Site visit w/ Kris
1-22-08

Re: Certification Submittal for Final Building Certificate of Occupancy for
Bldg Renovation & Addition @2910 San Mateo, [H-18 / D067]
2910 San Mateo Blvd NE
Architect's Stamp Dated 02/19/09

Re: **Permanent Certificate of Occupancy for Building Renovation and Addition at
2910 San Mateo Boulevard NE.**

RE: Shops at San Mateo, 2910 San Mateo Blvd NE
Sheet C103 - DETAILS

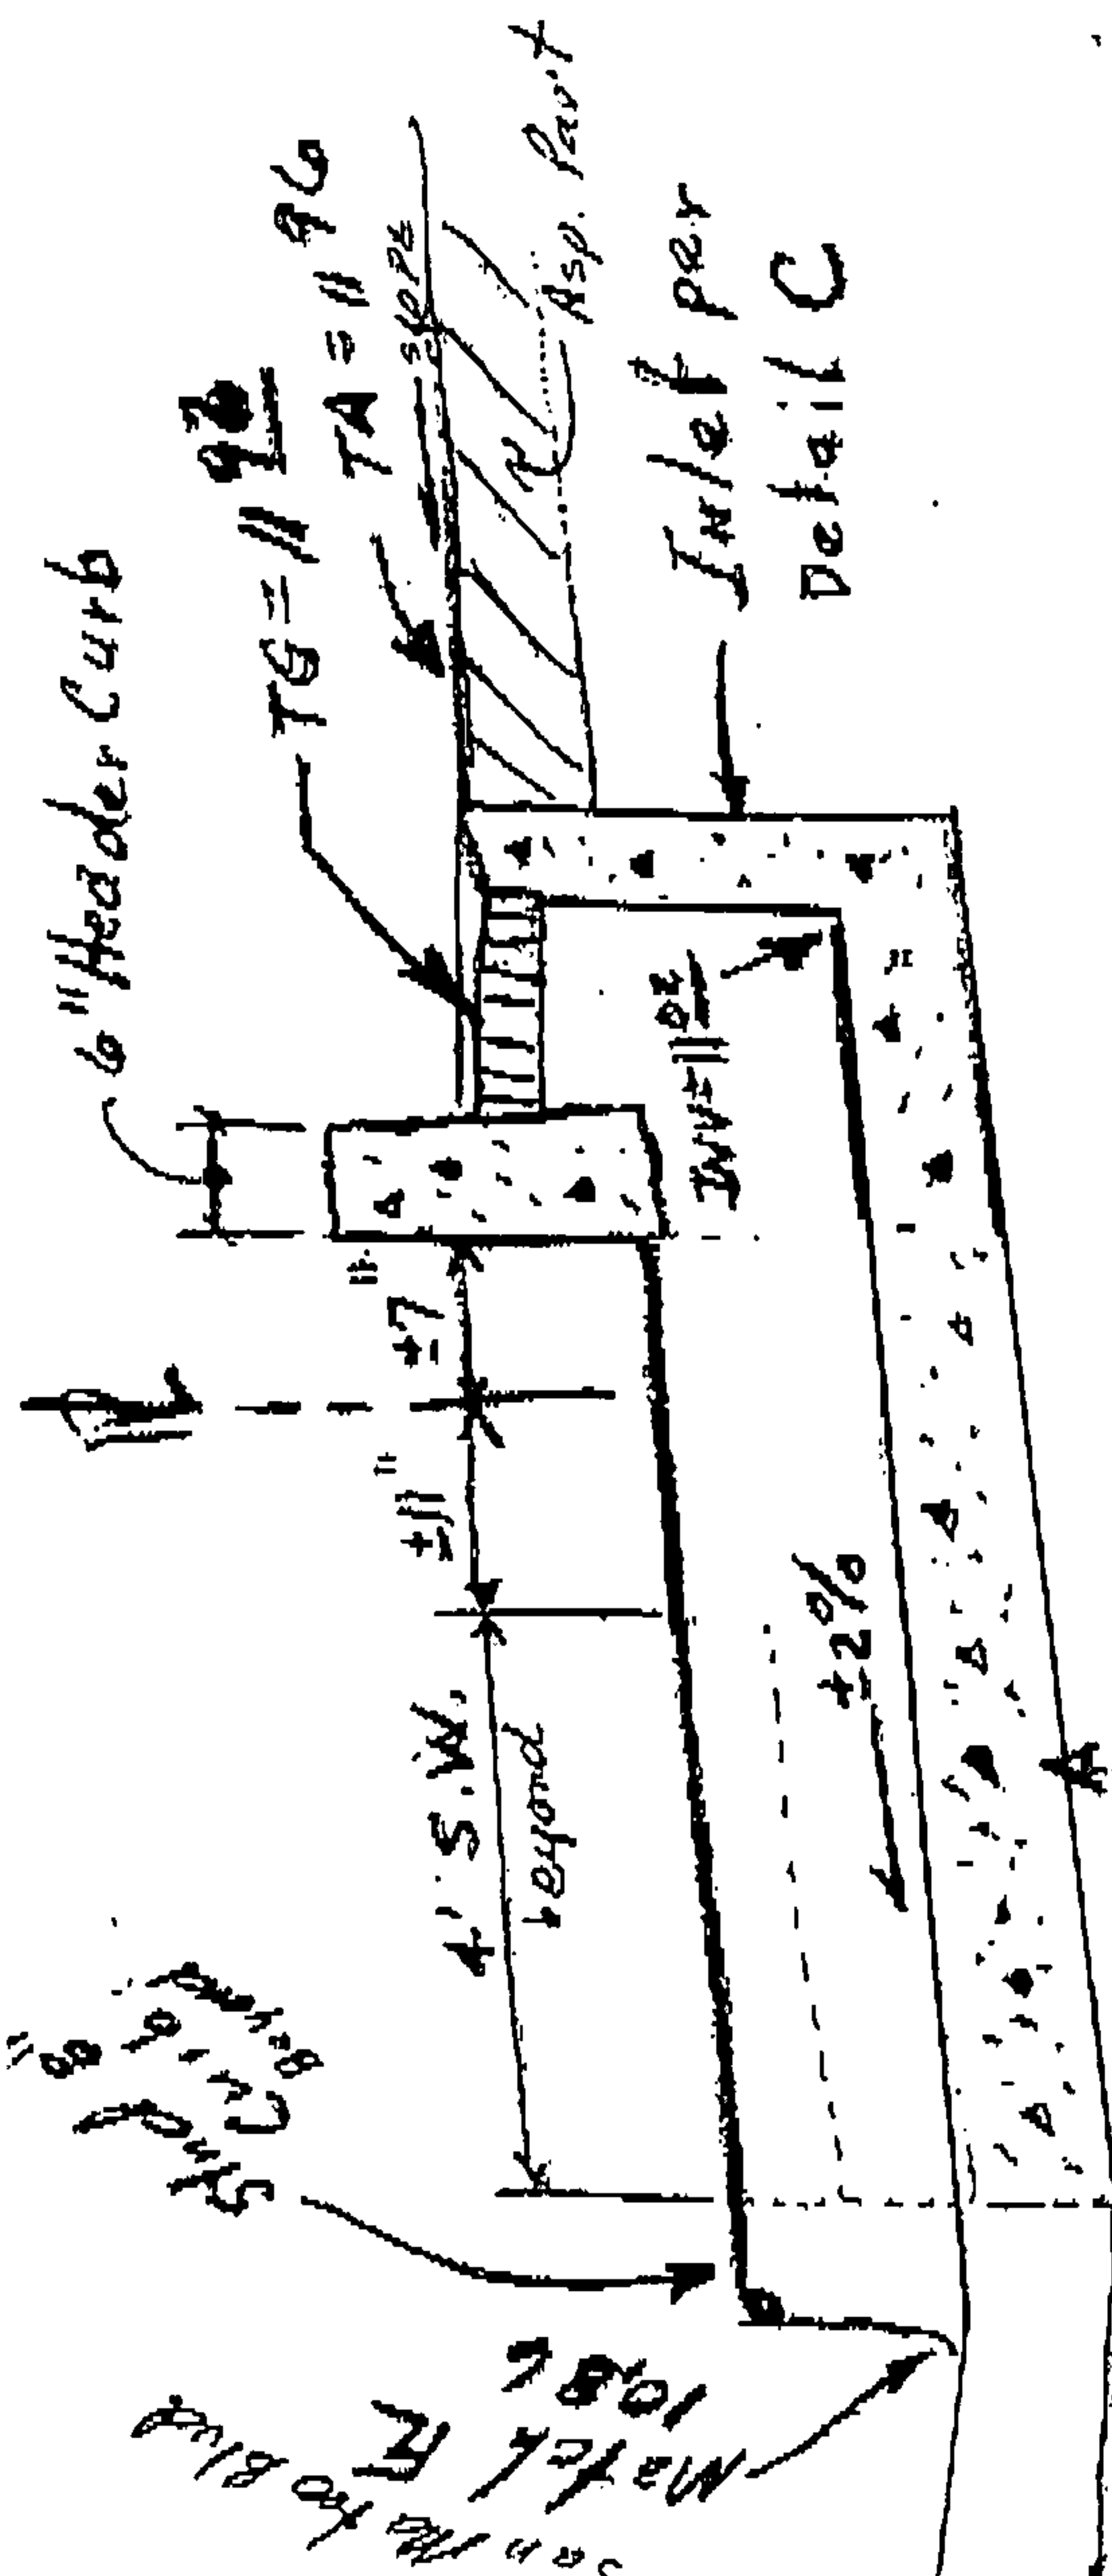
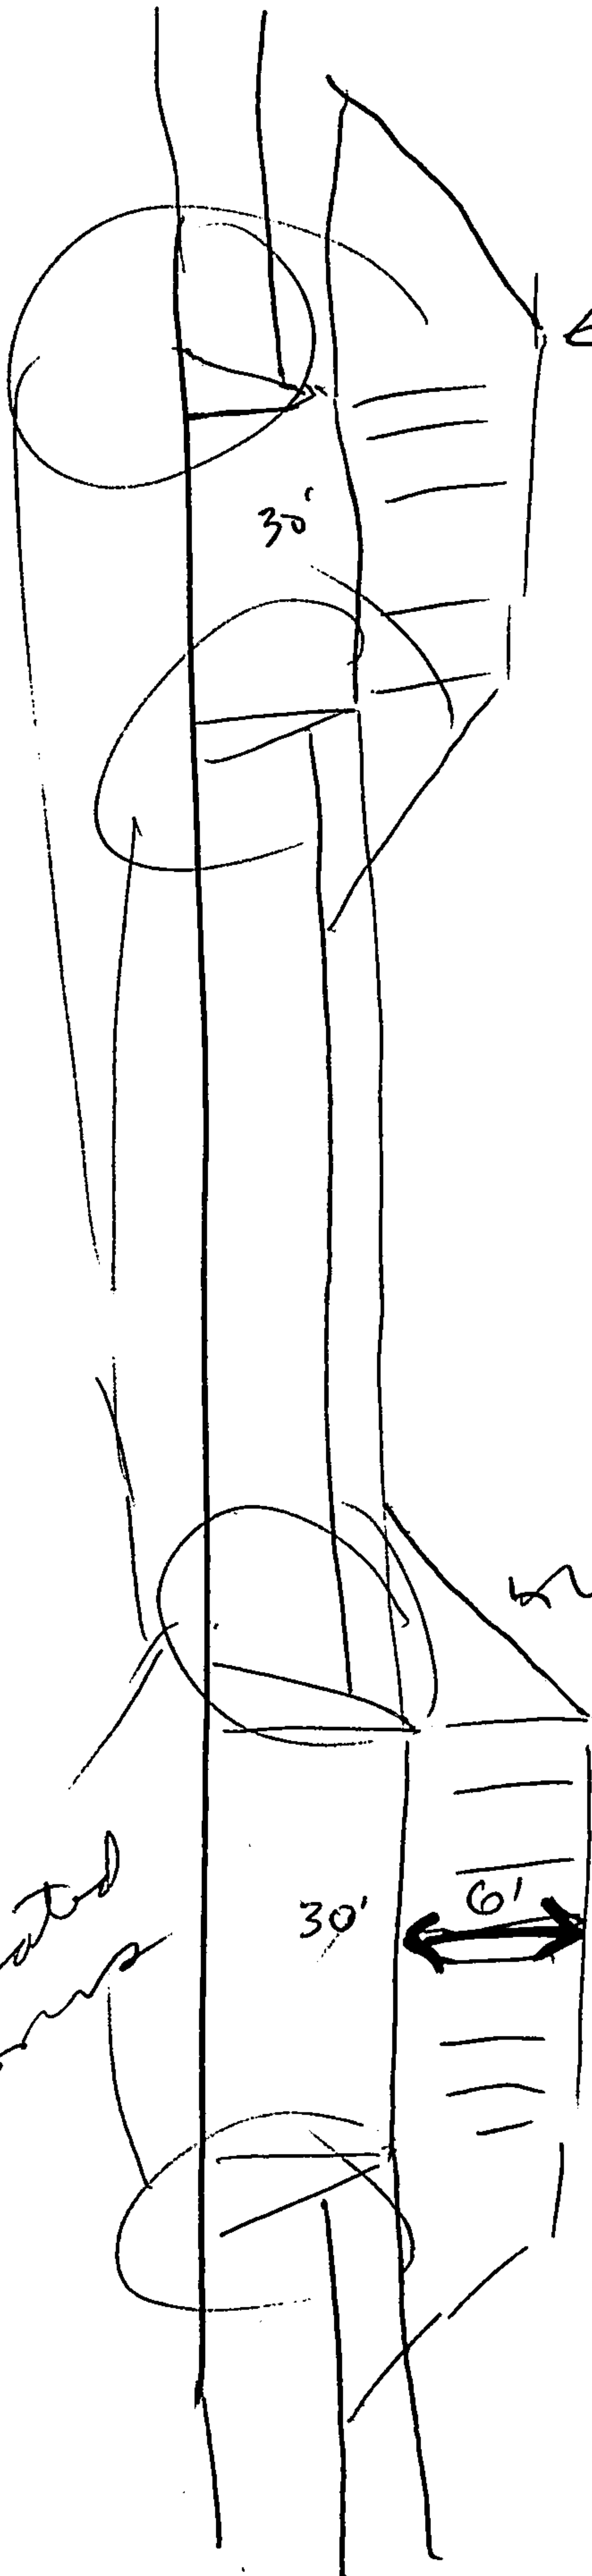
Based upon the information provided in your submittal received 1-30-09, the above referenced DETAIL SHEET (C103) is approved for Special Order 19 (SO-19), with one required adjustment:

Based upon our telephone discussion, the original inlet location encroached on the public R/W for San Mateo Blvd. The inlet must be shifted east of the Property Line and the Sidewalk Culvert extended to the inlet wall (similar to detail attached to plan).

Relocate INLET AND
 EXTEND SW CULVERT
 BEYOND R/W LINE
 1/30/09

← need
public SW
esmt

Need
public
SW
esmt

Don't
need
truncated
domes

once apply for
public SW esmt,
can get a temp CO
— need a revised
plan or sketch

5' SW Culvert
 per STD DWG. 2236
